Access Compliance Report

Public Rights-of-Way

Intersection ID: N/A	Main Street: MARKLAND_DR	Cross Street: WEDGEFIELD_DR	Location: NE
ADA ID: 572144876094	Ramp Type: PerpDiag	Initial Pass/Fail: Fail	Overall Compliance: No
		Severity Score: 37.5

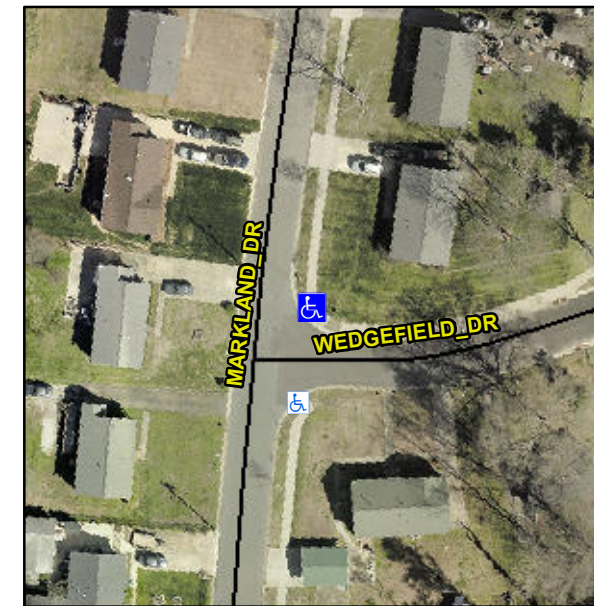
Not Found, R304.2.2, R304.5.3

Compliance	Description	Data	Compliance	Description	Data
N/A	Ramp Length (in)	86.0	No	Ramp Slope (%)	8.8
Yes	Ramp Width (in)	48.0	No	Ramp XSlope (%)	7.6
N/A	Flare Type LT	N/A	N/A	Flare Type RT	N/A
N/A	Flare Slope LT (%)	N/A	N/A	Flare Slope RT (%)	N/A
N/A	Flare Traversable LT?	N/A	N/A	Flare Traversable RT?	N/A
N/A	Landing Length (in)	N/A	N/A	DWS Provided?	N/A
N/A	Landing Width (in)	N/A	N/A	DWS Contrast?	N/A
N/A	Landing Slope (%)	N/A	N/A	DWS Length (in)	N/A
N/A	Landing X Slope (%)	N/A	N/A	DWS Full Width?	N/A
N/A	Landing Curb? (Y/N)	N/A	N/A	DWS Offset (in)	N/A
N/A	Shared Landing?	N/A			
N/A	Gutter Ponding?	N/A	N/A	Gutter Slope (%)	N/A
N/A	Gutter Lip Ht (in)	N/A	N/A	Gutter X Slope (%)	N/A
N/A	Painted X Walk1?	No	N/A	Painted X Walk2?	No
	X Walk 1 Direction	To W		X Walk 2 Direction	To S
N/A	X Walk 1 Width (in)	N/A	N/A	X Walk 2 Width (in)	N/A
	X Walk 1 Slope (%)	1.2		X Walk 2 Slope (%)	4.2
	X Walk 1 X Slope (%)	7.9		X Walk 2 X Slope (%)	3.2

Remove & Replace Curb Ramp With Two New Directional Ramps or Equivalent.
